DATE: September 21, 2016
TO: Thomas Tunny, Reuben, Junius & Rose LLP
FROM: Rich Sucre, Planning Department
RE: PPA Case No. 2016-004823PPA-02
744 Harrison Street

Preliminary Project Assessment

Date: September 21, 2016
Case No.: **2016-004823PPA-02**
Project Address: 744 Harrison Street
Block/Lot: 3751/028 and 054
Zoning: MUO (Mixed-Use Office) Zoning District
SoMa Youth & Family Special Use District
85-X Height & Bulk District
Existing Area Plan: East SoMa Plan Area
Proposed Area Plan: Central SoMa Plan Area
Project Sponsor: Thomas Tunny, Reuben, Junius & Rose, LLP
415-567-9000
Staff Contact: Ming Yeung – 415-575-9183
ming.yeung@sfgov.org

Title: 744 Harrison/29 Rizal Shadow Fan
Comments: Assuming 85' tall building and rooftop appurtenances.
Printed: 21 July, 2016

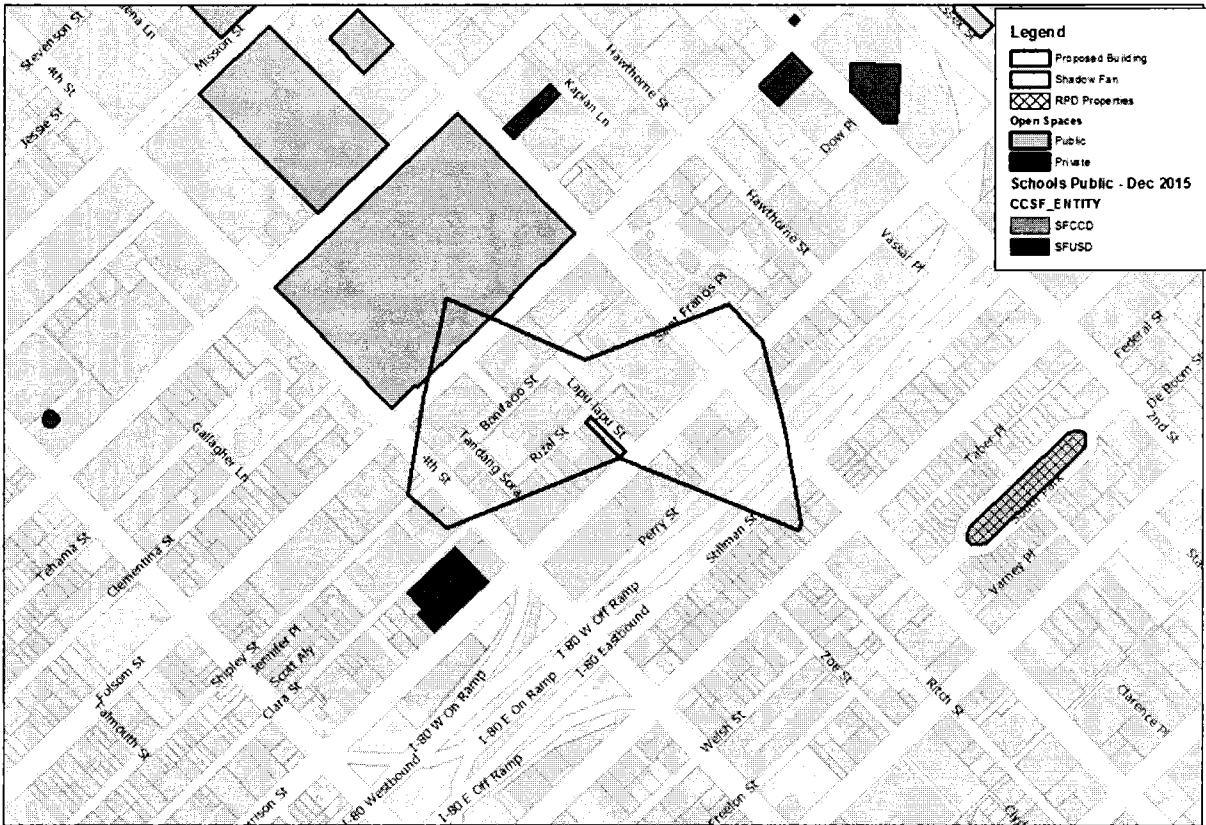
9. **Shadow.** The proposed project would result in construction of a building greater than 40 feet in height. A preliminary shadow fan analysis prepared by Planning Department staff indicates that the proposed project would potentially cast shadow on Moscone Center. Therefore, additional shadow analysis is anticipated.

development potential of the site in question, to reduce substantial shadow impacts on public plazas and other publicly accessible spaces other than those protected under Section 295. A preliminary shadow study was conducted by Staff in conjunction with this PPA Application, and it indicated that the project could potentially cast a shadow on the Moscone Center, open space protected under Planning Code Section 147. As indicated above, further shadow analysis may be required as part of the Environmental Evaluation.

744 Harrison Street - Places of Entertainment

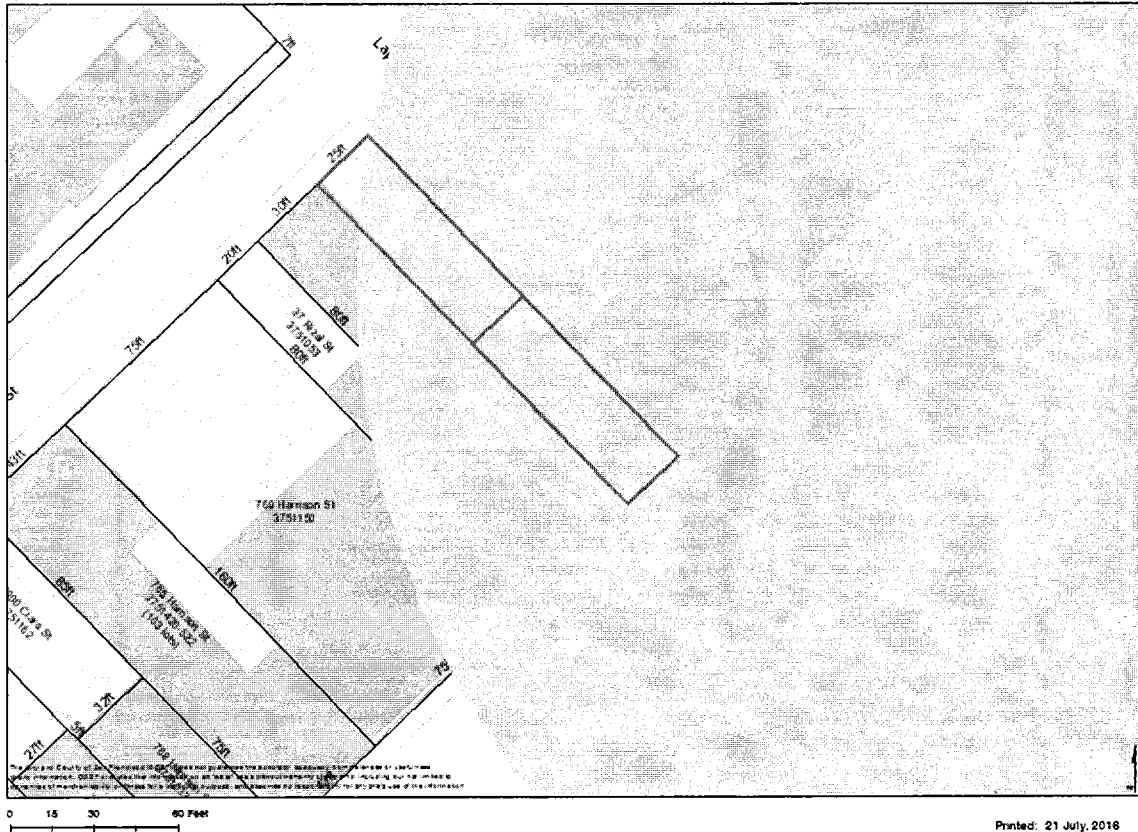
31. **Noise Regulations Relating to Residential Uses Near Places of Entertainment (POE).** New residential development within 300 feet of a Place of Entertainment must go through an Entertainment Commission outreach process ([Ordinance Number 070-015](#)). In addition, new residential development will also be required to record a Notice of Special Restrictions (NSR) on the site. The subject site is located within 300 feet of an existing POE, see enclosed map. Please note that the Planning Department will not consider an entitlement application complete until the following are completed:

- (A) The Entertainment Commission has provided written notification to the Planning Department indicating that it either did not wish to hold a hearing, or that it held a hearing and the Project Sponsor attended; and
- (B) The Project Sponsor has included a copy of any comments and/or recommendations provided by the Entertainment Commission regarding the proposed Project as well as the date(s) when those comments were provided. This shall be done as an additional sheet in any plan set submitted to the Planning Department and as an attachment in an entitlement application.
